MEMORANDUM

REVIEW TYPE: Preliminary Plan Review

PROJECT NAME: Four Corners

CASE #: 120060800

PRELIMINARY PLAN
 SCALE 1/8"

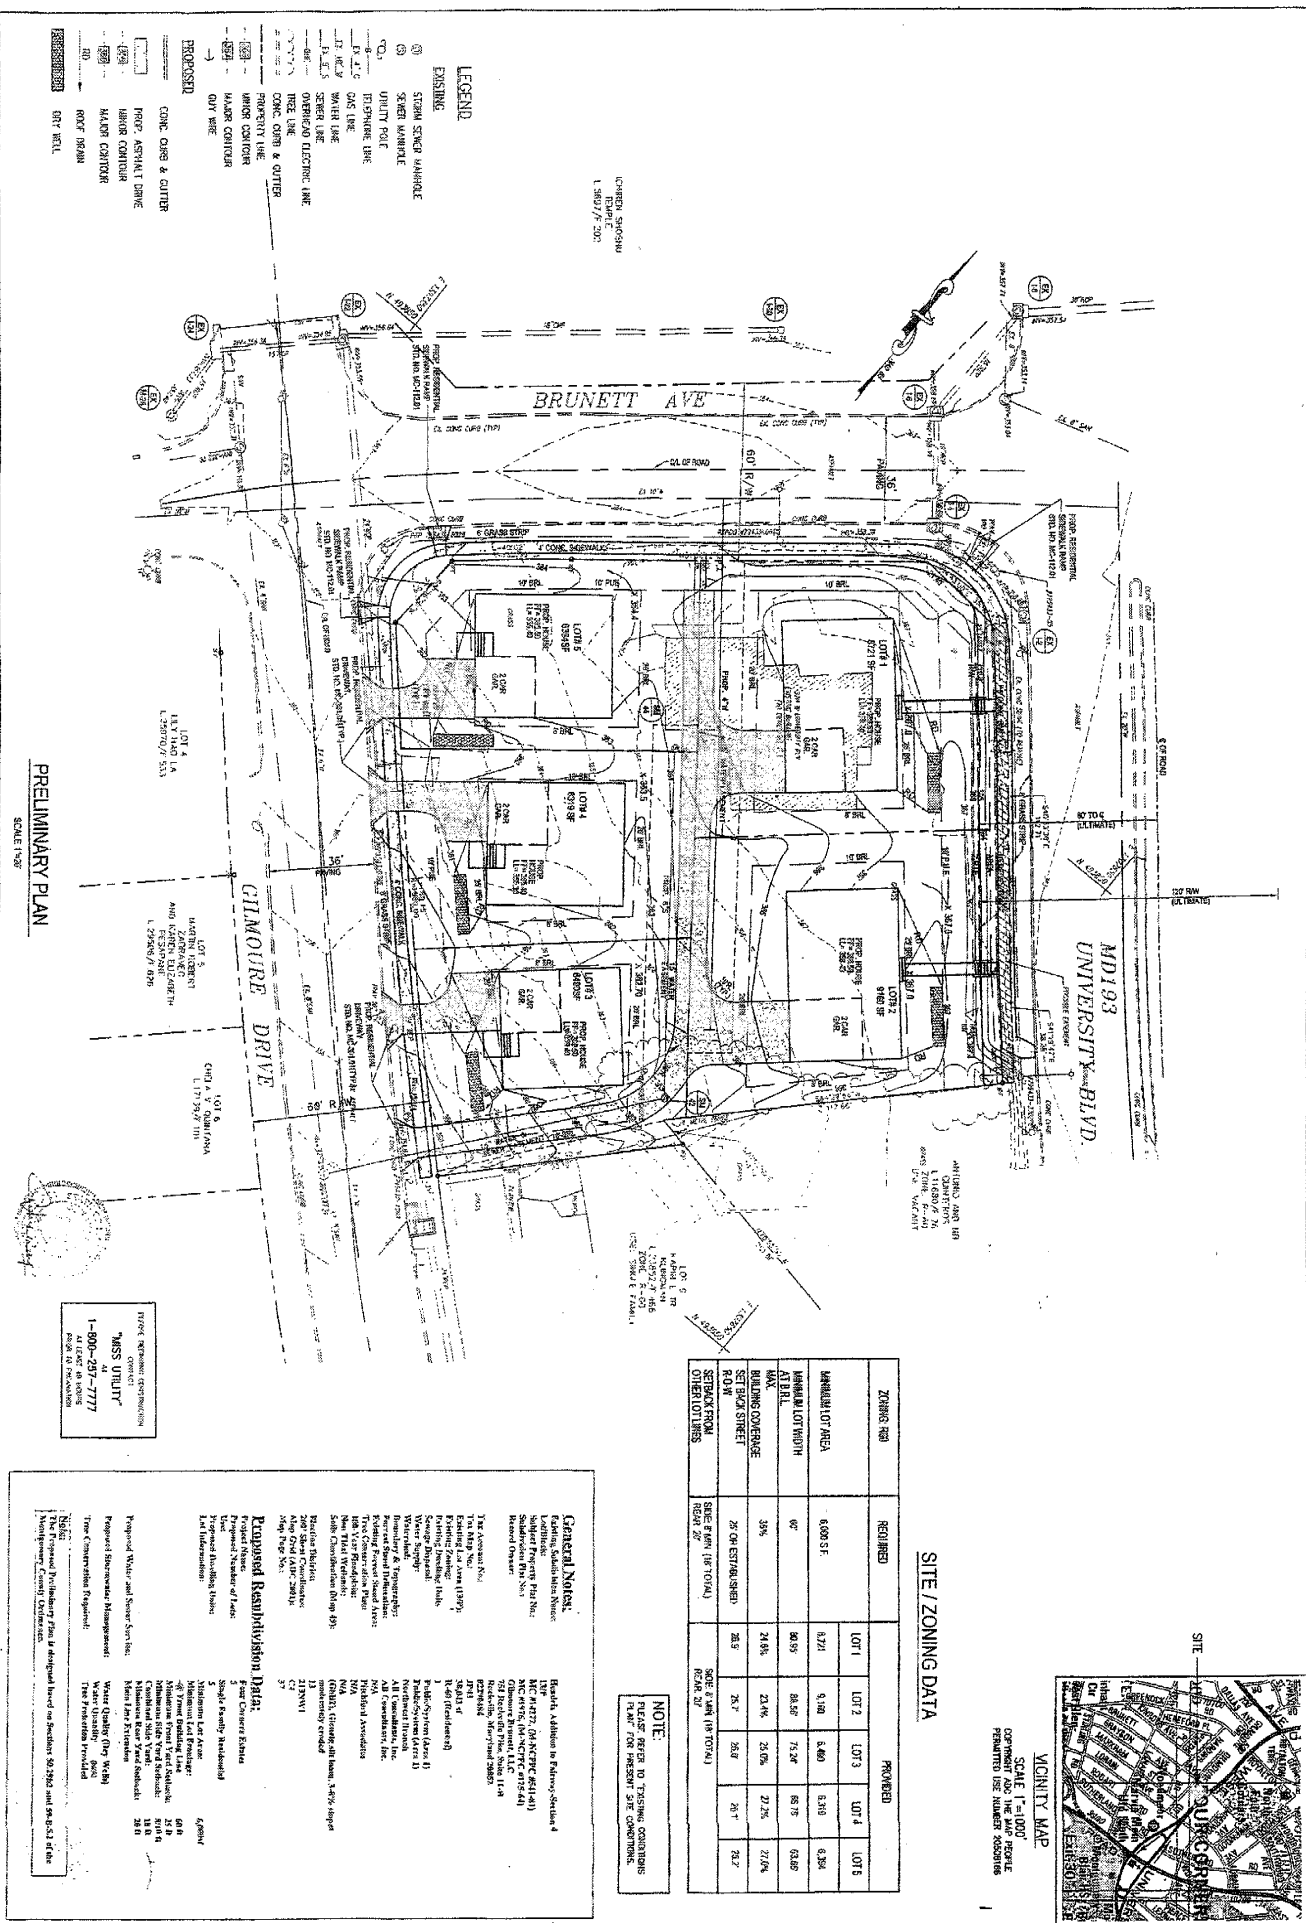
1. This property is exempt from Forest Conservation Law per 4-06139E (Small Property).
2. Consider having all units configured to a rear entry off of the alley, to minimize imperviousness.

3. The tree save plan needs to show all onsite trees $\geq 6"$ DBH. All offsite trees $\geq 24"$ DBH within 100' of the property line need to be shown, as well as offsite trees $\geq 6"$ DBH within 25' of the LOD.

4. Clear identification of trees to be protected, trees to be removed, and CRZs for these trees must be shown.
5. The plan must include the arborist's detailed evaluation and recommendations regarding the protection of the tree. The arborist must sign, stamp, and date the tree save plan.

6. Provide detailed notes that cover minimum M-NCPPC inspections (i.e., pre-construction meeting, inspection after protection measures are put in place and prior to start of clearing and grading, after construction inspections, any post-construction tree care measures, etc.).

7. Tree protection measures must be in place before any demolition, grading, clearing, or construction.

- Revise tree save plan.
